Access Compliance Report Public Rights-of-Way (Curb Ramps)

Main Street: WOODLAND_DR Cross Street: MELVIN_WY Location: W

ADA ID: RPAT211109135212 Ramp Type: Type 1 - Perpendicular Diagonal Initial Pass/Fail: Pass Overall Compliance: No Severity Score: 5

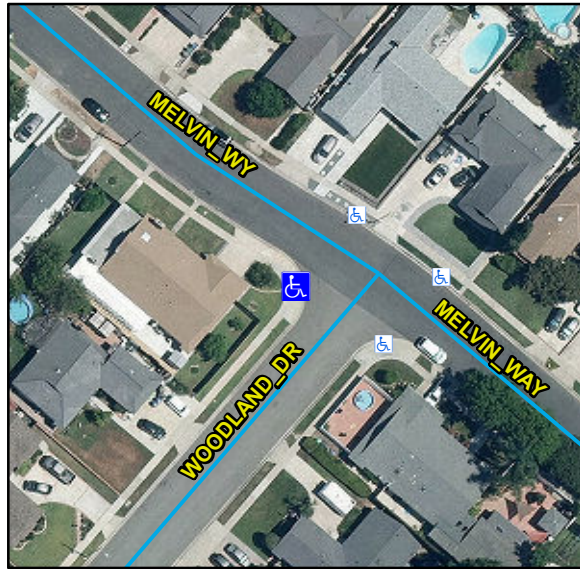
Compliance	Description	Data	Compliance	Description	Data
N/A	Ramp Length (in)	45	N/A	Flare Type LT	
Yes	Ramp Width (in)	60			Sloped
Yes	Ramp Run Slope (%)	7.9	N/A	Flare Slope LT (%)	2.8
Yes	Ramp Cross Slope (%)	0.4	N/A	Flare Traversable LT	No
N/A	Landing Present	Yes	N/A	Flare Type RT	
N/A	Landing Length (in)	58			Sloped
Yes	Landing Width (in)	60	N/A	Flare Slope RT (%)	4.3
Yes	Landing Run Slope (%)	1.6	N/A	Flare Traversable RT	No
Yes	Landing Cross Slope (%)	1.2	Yes	DWS Provided	Yes
N/A	Landing Movement Obstructed?	Yes	Yes	DWS Contrast	Yes
	Landing Movement Type	Curb	Yes	DWS Length (in)	36
N/A	Landing Shared	No	Yes	DWS Full Width	Yes
N/A	Clear Space	Yes	Yes	DWS Offset Left (in)	0
N/A	Clear Space To Crosswalk (in)	48	Yes	DWS Offset Right (in)	N/A
N/A	Marked Crosswalk 1	No	N/A	Marked Crosswalk 2	No
	Crossing 1 Direction	SE		Crossing 2 Direction	NE
	Marked Crosswalk 1 Width (in)	N/A		Marked Crosswalk 2 Width (in)	N/A

N/A	Ramp Inside Crosswalk 1	N/A	Yes	Ramp Inside Crosswalk 2	N/A
	Crossing 1 Slope (%)	5.1		Crossing 2 Slope (%)	4.2
	Crossing 1 Cross Slope (%)	1.4		Crossing 2 Cross Slope (%)	1.2
Yes	Gutter Ponding	No	No	Curb Slope	9.7
Yes	Gutter Lip Height (in)	0		Road Run Slope (%)	0.6
No	Gutter Run Slope (%)	6		Road Cross Slope (%)	4.6
Yes	Gutter Cross Slope (%)	0.9			
Yes	Overall Surface Condition: Acceptable		Yes	Perp Joint Present	Yes
	Cross Gutter Present?	No		Spandrel Present?	No
	Replace Cross Gutter?	N/A		Replace Spandrel?	N/A

Remove & Replace Curb Ramp With Two New Directional Ramps or Equivalent. Remove & Replace Gutter.
